**CITY OF BEAUFORT
DESIGN REVIEW BOARD
Staff Report
Meeting of March 10, 2016**

Case Number: 16-04 DRB.1
Project: 9 Sam's Point Road
Property Address: Parris Island Gateway & County Shed Road
Parcel #: R123 015 000 0160 0605 (a portion of this parcel)
Zoning: General Commercial
Design District: Sam's Point Road Design District
Type of Review: Preliminary Review – New Construction

The applicant is requesting to construct a new 3,500 square foot auto spa (car wash). The project is located on 1 acre on the west side of Sam's Point Road.

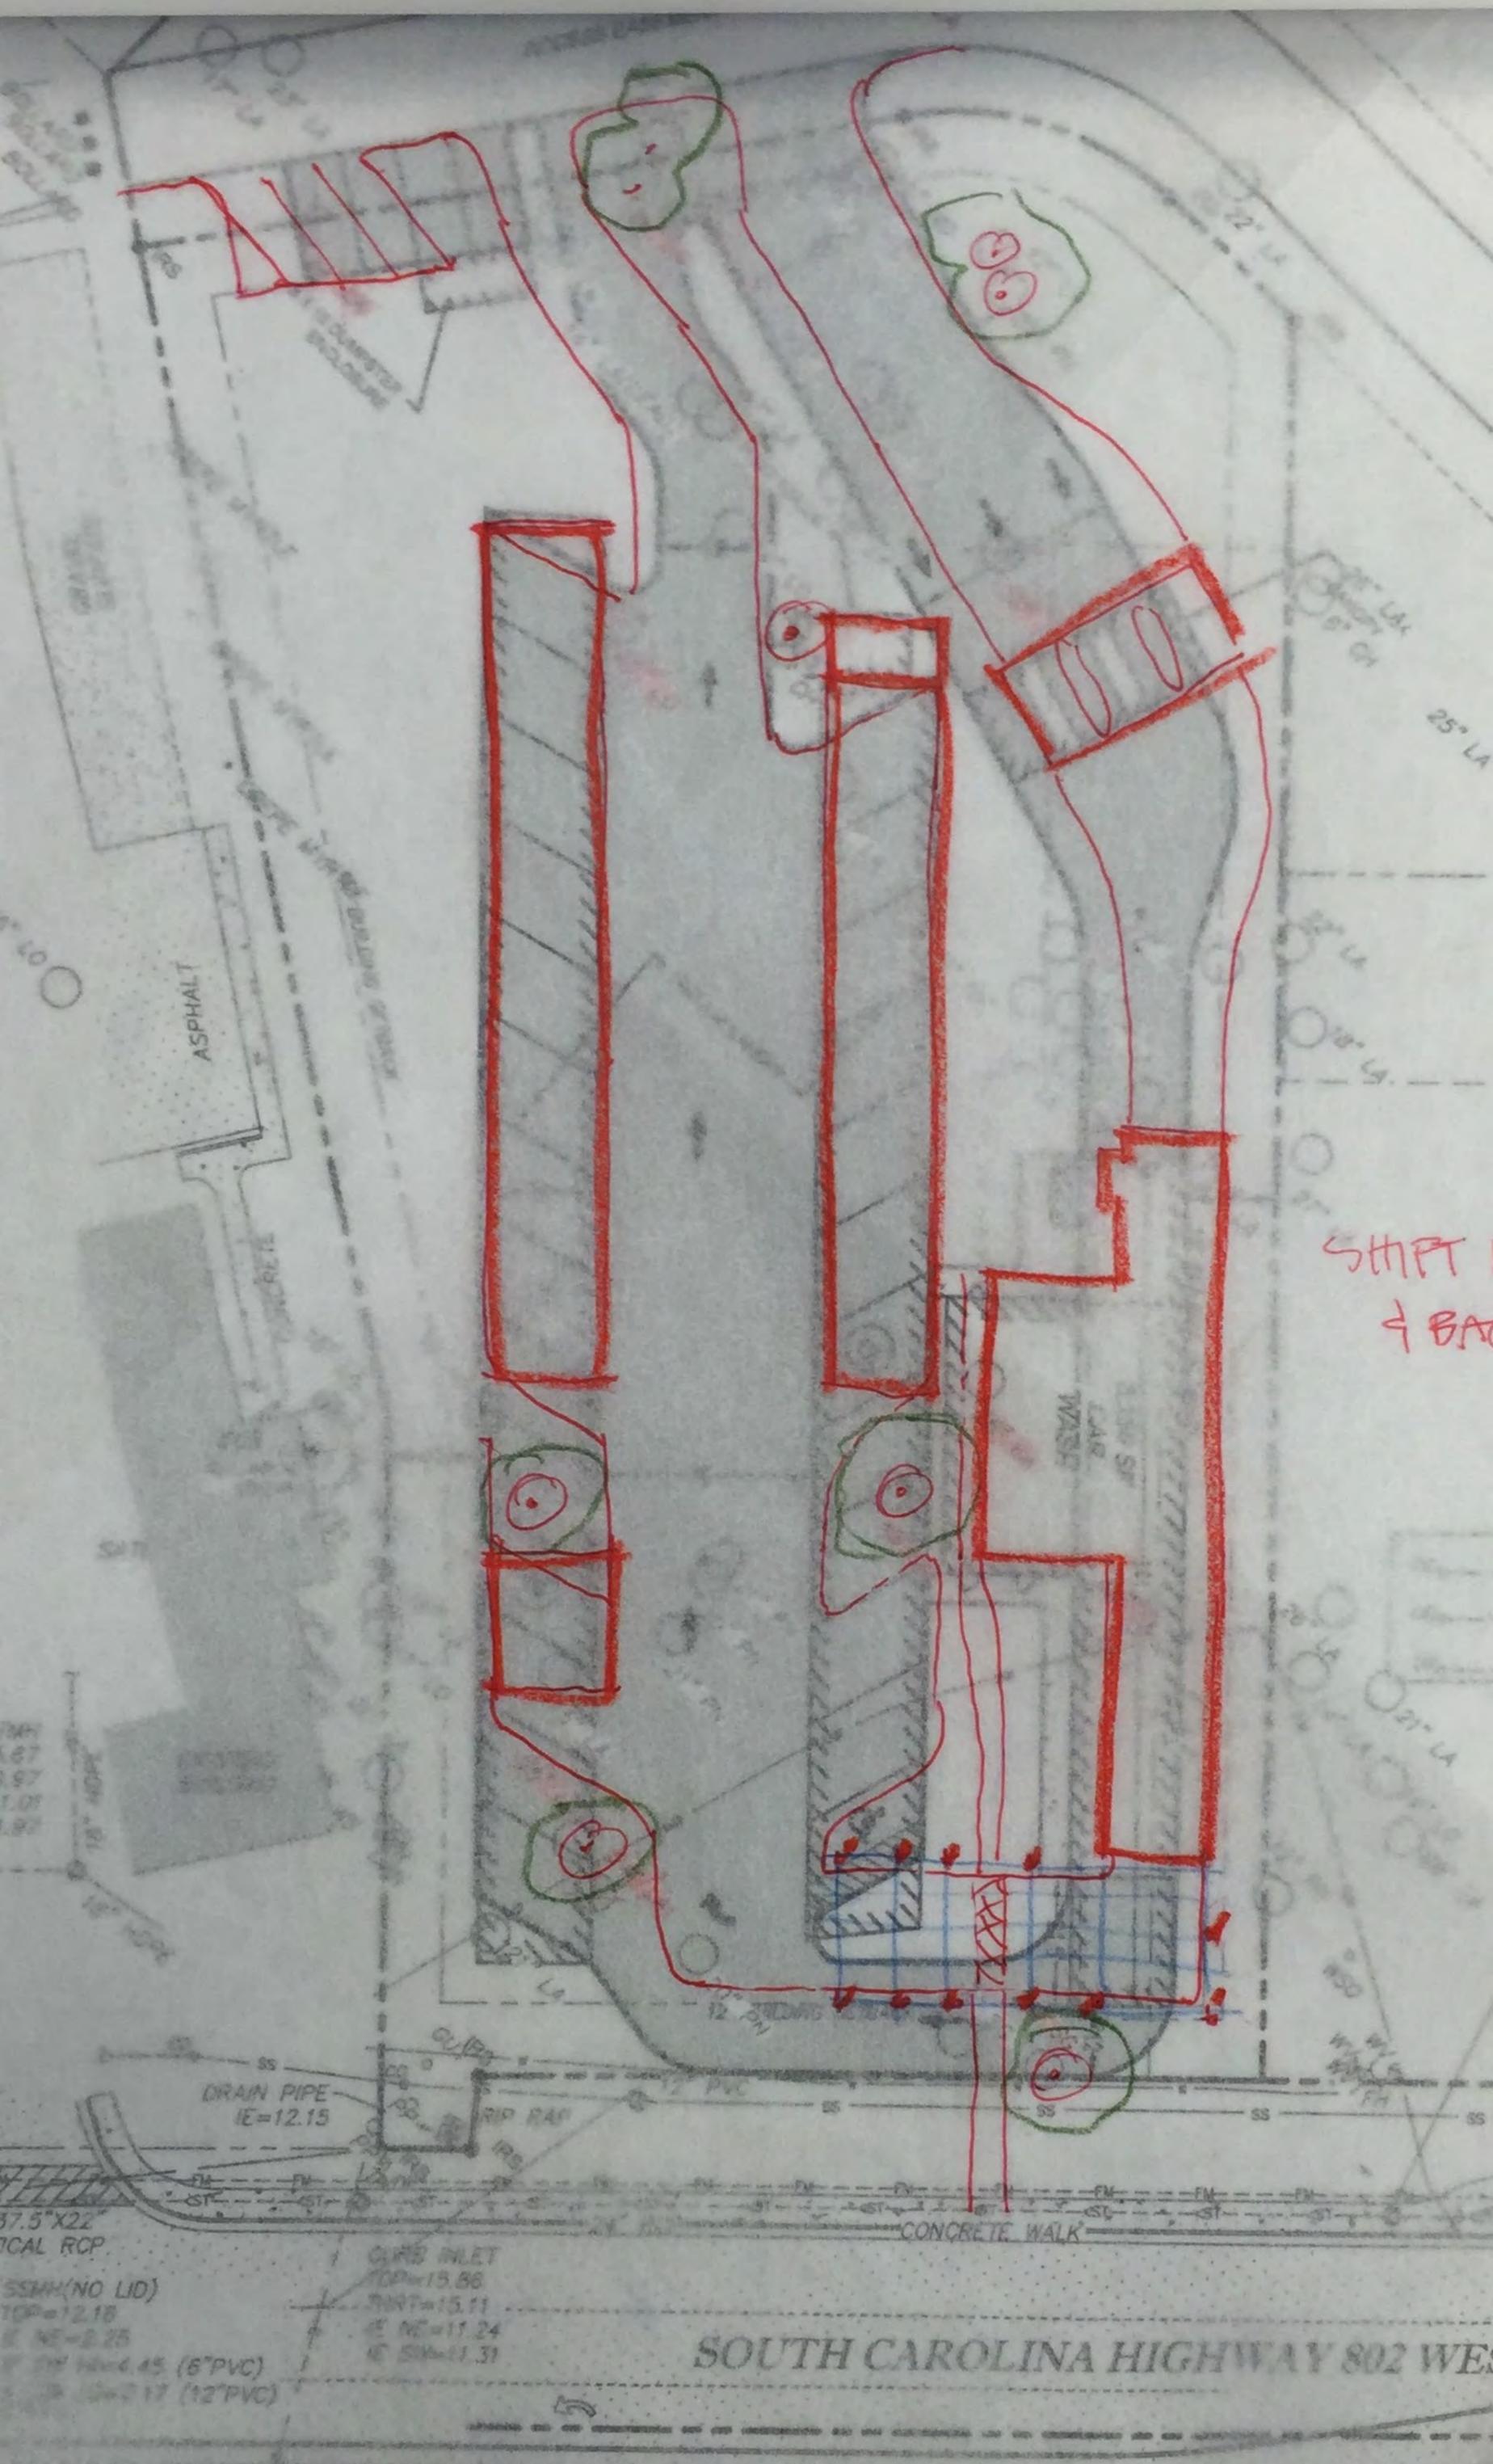
- This building is unique due to the very specific use and equipment it houses. At the street frontage, it is narrower than most buildings in this area. Additional elements, such as a portico and trellis, should be considered at the street frontage to mitigate this and bring it into full compliance with the build-to line (at least 50% of the site should comply with build-to line). More suggestions on this below.
- As a concept the design and detailing of the building seems to be compatible with the UDO and the area. For the canopies, please provide elevations of the street showing how the entire frontage will look with the canopies and the building. The canopy materials and colors should be compatible with the building.

Staff suggestions: the attached sketch depicts the following modifications that may help this building better comply with the intent of this area:

- Shift building back a few feet and northeast to the 10' setback line. This allows two of the trees to be retained
- Create a portico with support columns (in lieu of a cantilever) that continues into a trellis across the front of the property. This could help the building meet the intent of the build-to line by placing building elements along the frontage for at least 50% of the property.
- Modify the canopy to save some trees identified as good.
- Modify the entry drives to retain trees
- Modify parking along the rear access road to diagonal. Head-in is not permitted; this is similar to the Waffle House site.

CONCEPTUAL SITE PLAN

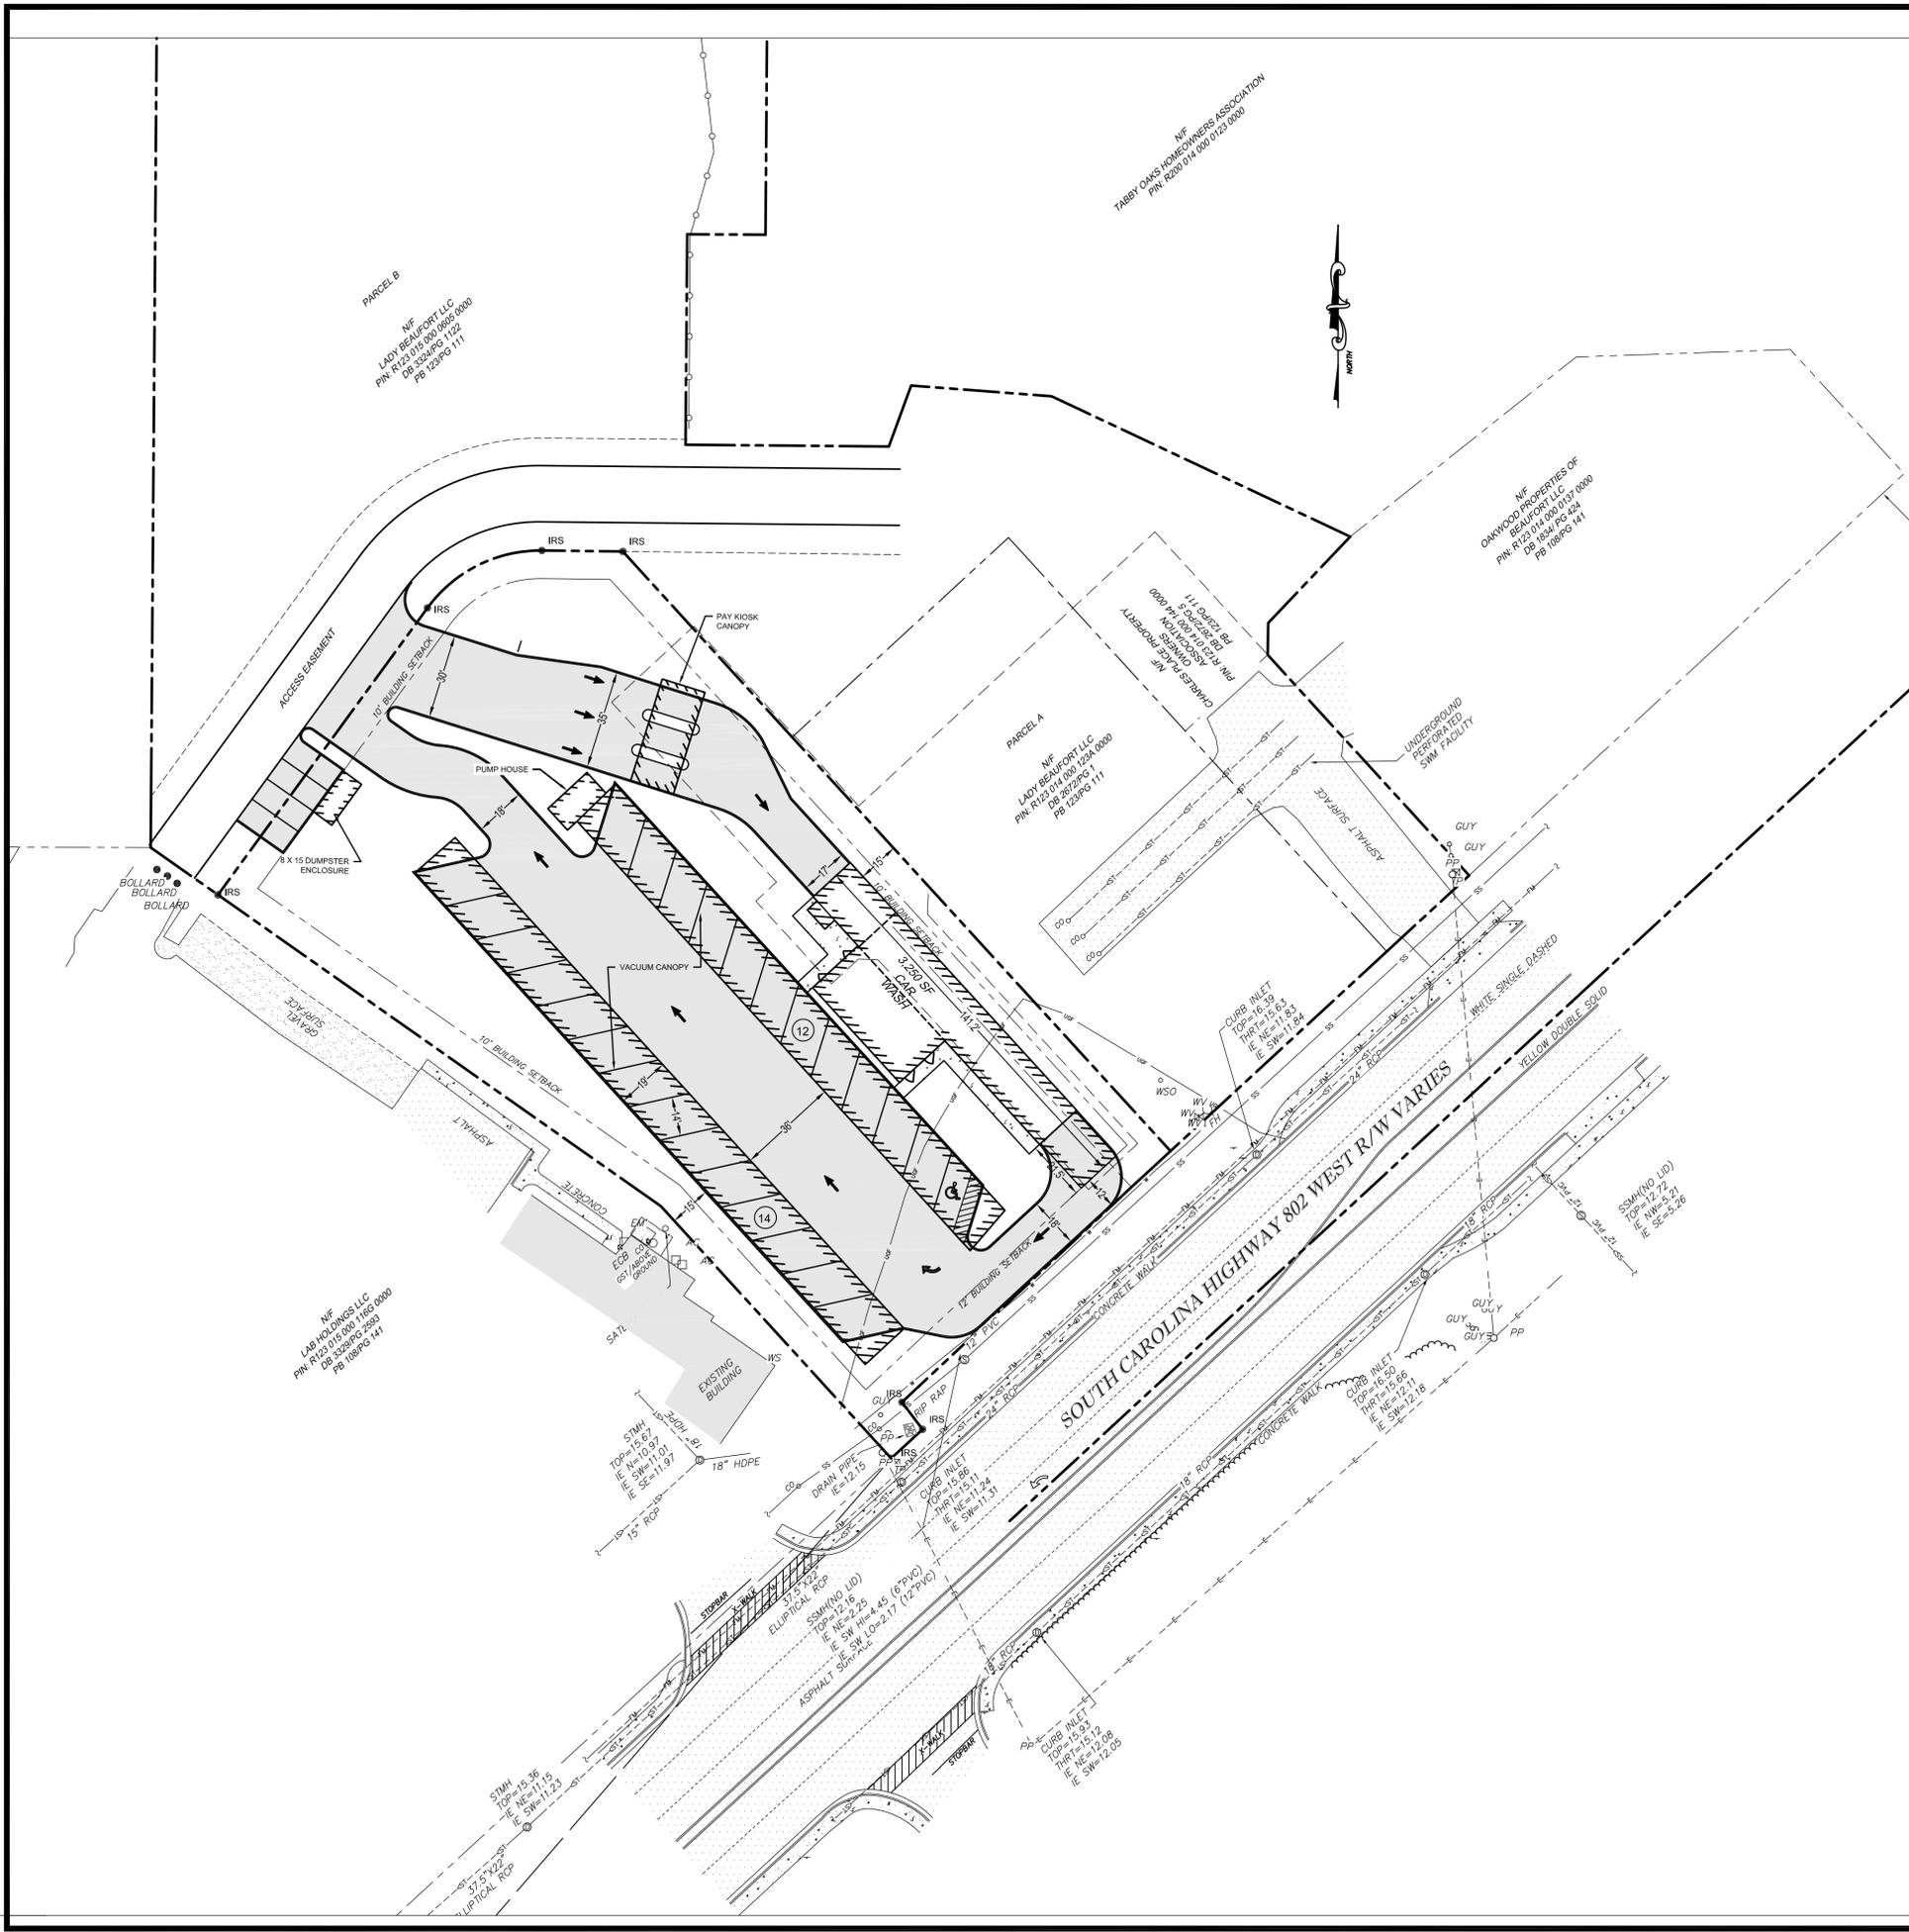
- Orientation:
 - The applicant and staff have discussed the possibility of rotating the building so that the long façade faces the street. This would serve to screen the street from the vacuum stalls/parking area and would help the applicant meet the build-to line requirement. Given the dimension of the building, this was unable to be accomplished.

- The alternative was to create a front portico onto the car-wash exit to allow the building to meet the build-to line. More discussion on this to follow.

- Vehicular Circulation:
 - The parcel will be accessed via a shared entry between 13 and 15 Sam's Point Road. That drive will connect into the Walgreens parking lot. There are no additional curb cuts on to Sam's Point Road. This is in keeping with the connectivity recommended by the Civic Master Plan.

- Pedestrian Circulation:
 - A sidewalk connection into the site should be established. Staff realizes that this is a vehicular-oriented business, however employees may choose to walk elsewhere for lunch, etc. so that connectivity should be provided.

- Parking:
 - All of the parking spaces shown are dual-purpose; they are for parking but also are under the vacuum canopy. There are no restrictions on this other than the impervious surface coverage and tree canopy relationship (1 per 55').

- Trees:
 - An arborist report has been done for this parcel (attached). It identifies a number of great and good trees (categories A & B in the report) on the property. There are some that will be difficult to work around and others that should be carefully considered. These later trees include: 24" sweet gum at the front of the property; 26" live oak on the southwest corner; 42" live oak adjacent to the building; 26" laurel oak at the vehicular entry to the property. Attached is a sketch that shows how those trees can possible be retained.

- For the remainder of the A & B trees to be removed, 1/3 of the caliper inches should be mitigated.
- Stormwater: How will this be handled?
- A landscape plan is required showing existing trees to be preserved and removed, and new landscaping meeting the mitigation requirements.

- All mechanical equipment, trash/recycling receptacles, and propane tanks must be shown on the plan. They must be screened from view and details of the screening shall be provided.
- A lighting plan, showing building and site lighting, will be required. Full-cut off fixtures are required for parking lot lighting.
